DEPARTMENT OF PUBLIC WORKS COUNTY OF HUMBOLDT

LAND USE DIVISION INTEROFFICE MEMORANDUM

RE: SUBDIVISION REQUIREMENTS - IN THE MATTER OF THE VALADAO, APPLICATION # PLN-2021-17560 FMS, APN 510-381-021, FOR APPROVAL OF A TENTATIVE MAP, CONSISTING OF 2.47 ACRES INTO 19 LOTS

DATE: 01/17/2024

Above: Typical section for widening Pickett Road

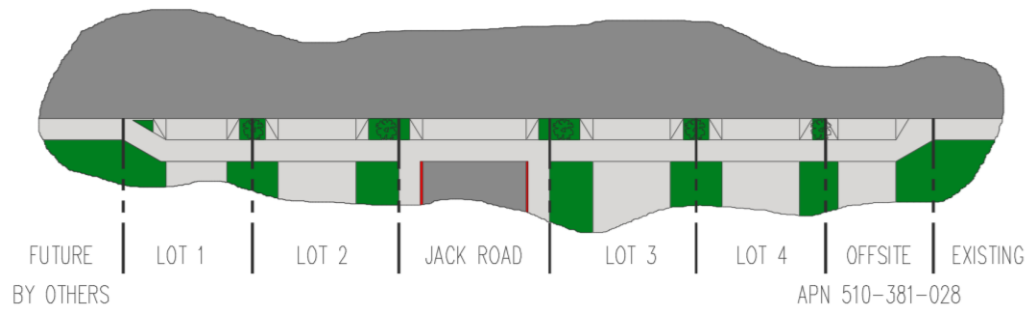
- (a) **Pickett Road (County Road No. 4M030)** shall be constructed having a typical section comprised of two 12 foot wide driving lanes, an 8 foot wide parking lane, a 5' wide landscape strip (4.5' wide useable) and 5' wide pedestrian sidewalk with Caltrans Type A2-6 portland cement concrete (PCC) curb and gutter fronting the subject parcel.

Above: Plan view of Pickett Road widening and Jack Way intersection

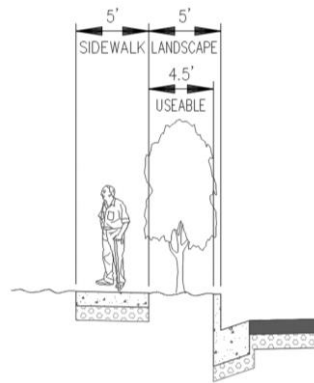
- (a) A stop sign shall be installed on Jack Way at its intersection with Pickett Road. A stop sign shall be installed on Jack Way at its intersection with Gwin Road. When the road is paved, a "stop" pavement marking and limit line shall be installed.

Above: Typical section for widening Gwin Road

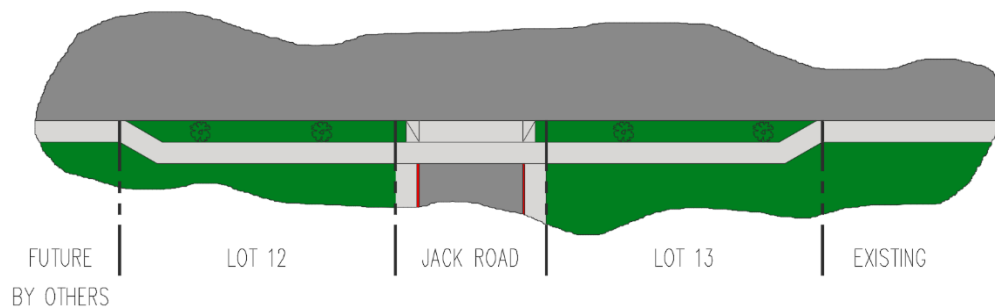
- (b) **Pickett Road (County Road No. 4M030) OFFSITE:** construct in fill curb, gutter, sidewalk, and urban driveway No. 1 across the frontage of APN 510-381-028. (This was the former access to the subject property.)
- (c) **Gwin Road** shall be constructed having a typical section comprised of two 12 foot wide driving lanes, an 8 foot wide parking lane, a 5' wide landscape strip (4.5' wide useable) and 5' wide pedestrian sidewalk with Caltrans Type A2-6 portland cement concrete (PCC) curb and gutter fronting the subject parcel.

Above: Conceptual diagram showing how landscape medians can be added where perpendicular parking is provided.

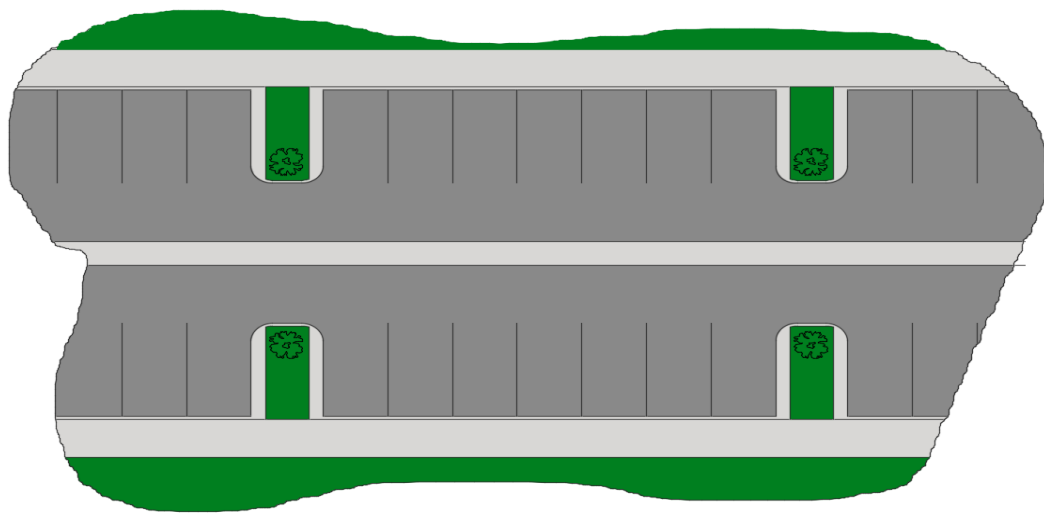
- (d) **Jack Way** shall be constructed 24' in width with a 3' wide concrete valley gutter in the center of the roadway. A 5' wide sidewalk shall be provided along both sides of the road. Where parking stalls are provided, the road shall have a 16' deep parking stall with Caltrans Type A1-6 curb and 7 foot wide sidewalk.

Parking stalls shall be a minimum of 9 feet wide in order to utilize a 24 foot wide roadway. A wider roadway is necessary if narrower parking stalls are desired.

The road is not designed for on-street parallel parking. In all areas where perpendicular parking is not provided, the curb shall be painted red or otherwise posted for no parking.

Where perpendicular parking is provided, provide landscaped medians periodically.
